Economic Commission for Europe

European Code for Inland Waterways (CEVNI)

Further amendments to CEVNI

Note by the secretariat

E.26 Winter harbour

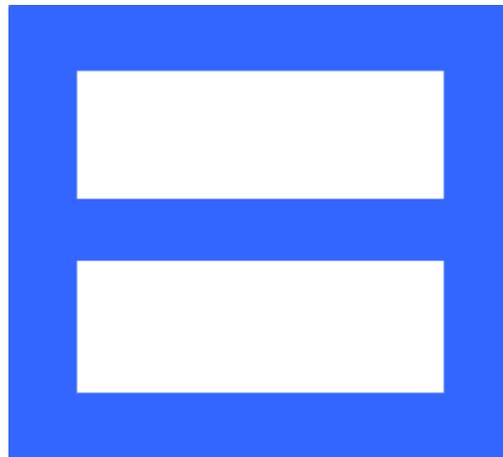
30. With the agreement of the CEVNI Expert Group and after approval by the Sava Commission Permanent Expert Group for Navigation, it is proposed to consider the inclusion of the following signs in Annex 7 of CEVNI:

E.27.1 Maximum number of vessels permitted to berth in winter shelter

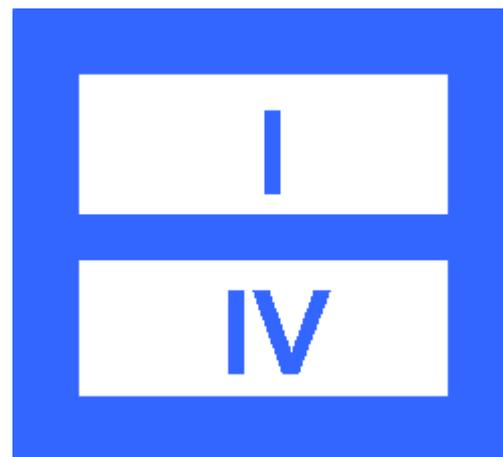
E.26.1 Maximum number of vessels permitted to berth in winter harbour

E.27 Winter shelter

Maximum number of vessels permitted to berth abreast

Maximum number of rows of vessels which are berthed abreast
